REVIEW OF THE RELIABILITY
OF
BRUCE 'B' RRS DUAL COMPUTER SYSTEM

FINAL REPORT

A report prepared for the
Atomic Energy Control Board
Ottawa, Canada

28 July 1995

Figure RRS-5-3 Effect of Software Loading

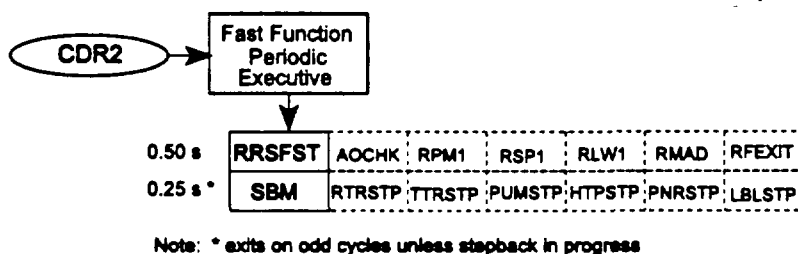
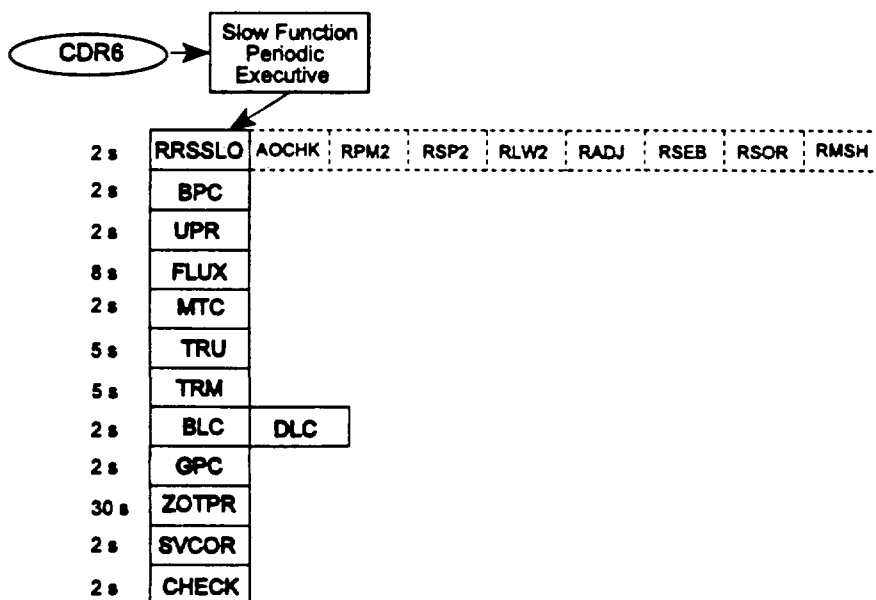
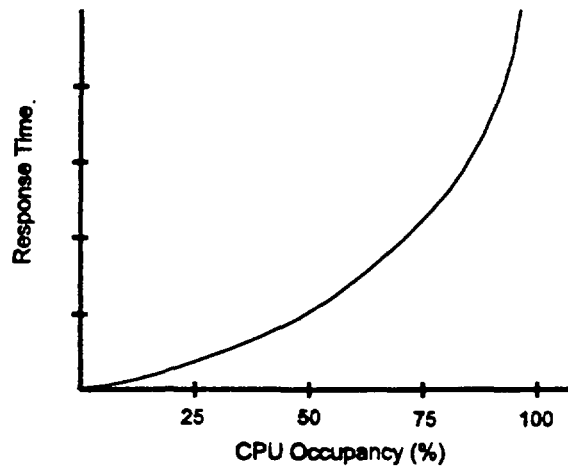
NOMENCLATURE: Digital Control Computer Software Loading

FUNCTION: The load imposed by the application SW on the Varian V72 CPU. The particular parameter which indicates how busy the CPU becomes, is known as CPU occupancy. As CPU occupancy becomes higher, response time to such things as periodic function requests (Figures RRS-5-1 and RRS-5-2) become longer, as illustrated in Figure RRS-5-3. In addition, as CPU occupancy increases, there is less available capacity to handle additional requirements even if they are of short duration (e.g., scanner interrupts).

During regular operation (i.e., when a step-back is not taking place), the SBM program executes every 0.25 s, with alternate executions involving no computation. It is uncertain how much of an additional effect a step-back has on CPU occupancy as a result of the SBM performing additional computations during these alternate executions, which are required during a step back involving the drop of the four MCAs.

REMARKS: During the trip to Bruce 'B', it was revealed that a loading analysis was performed during commissioning. The fixed head disk was replaced by MegaRam, which should not have impacted the loading. Various SW modifications have been made which would have increased the loading slightly from its original value. Presently, Ontario Hydro estimates the CPU occupancy to be between 75% and 95%, probably 85%. Additional SW modifications are pending which will increase the load further. Furthermore, it is understood that the SW loading is going to be measured soon by Ontario Hydro, when the reactor is scheduled to be shut down.

Figure RRS-10-1. Watchdog Timer Circuit

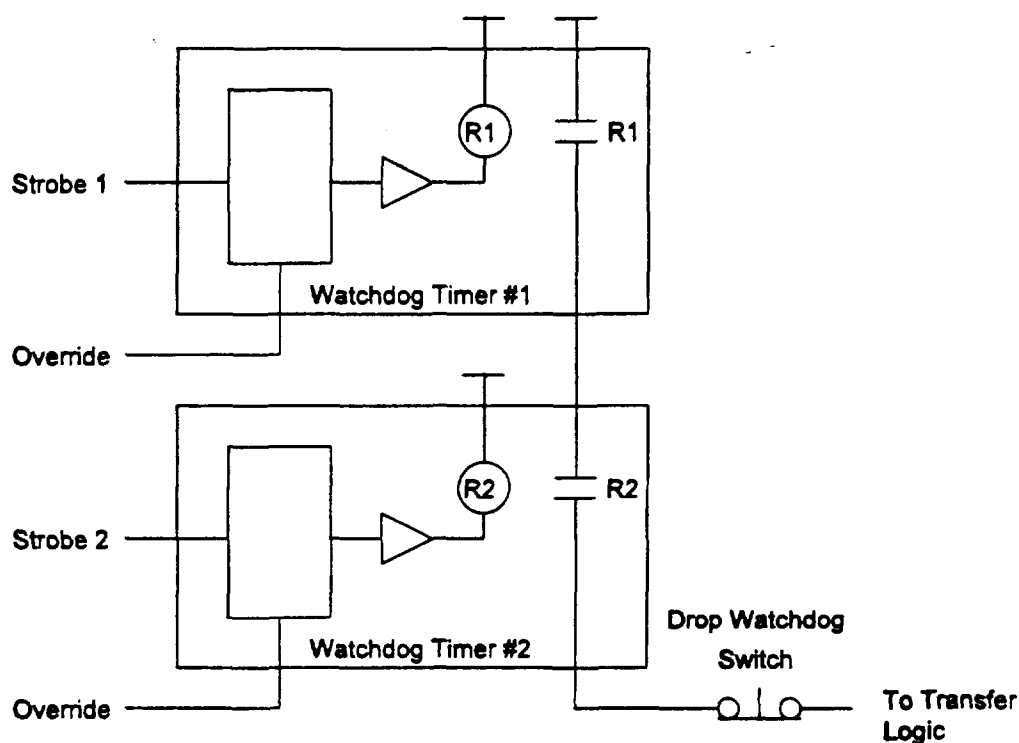
NOMENCLATURE: Digital Control Computer Watchdog Timer

FUNCTION: Two watchdog timers are used per DCC. The contacts of the two timers are connected in series, such that a failure of either watchdog will cause a transfer of control to the other DCC (Figure RRS-10-1). Via hardware components, the watchdog timer time-out is set at 2.5 s. Within the SW, though, there is an additional watchdog time-out of 25 s.

The Executive Time Check (EXTC) runs every 0.5 s. A SW counter, called OPMON, is checked by EXTC. If OPMON is not zero, it is incremented by one and the watchdog timer is reset to prevent it from timing out. If the watchdog timer times out, all digital outputs, including the interlock relays, are opened to isolate this DCC and connect the other DCC to the field. Within the background executive loop, OPMON is set to -50. If OPMON reaches 0, (i.e., 25 s have elapsed since the last execution of the background executive loop), 2.5 s later the watchdog timer will drop out. Therefore, a total of 27.5 s must elapse before the watchdog timer will drop out if the DCC SW fails such that the background executive loop is not executed.
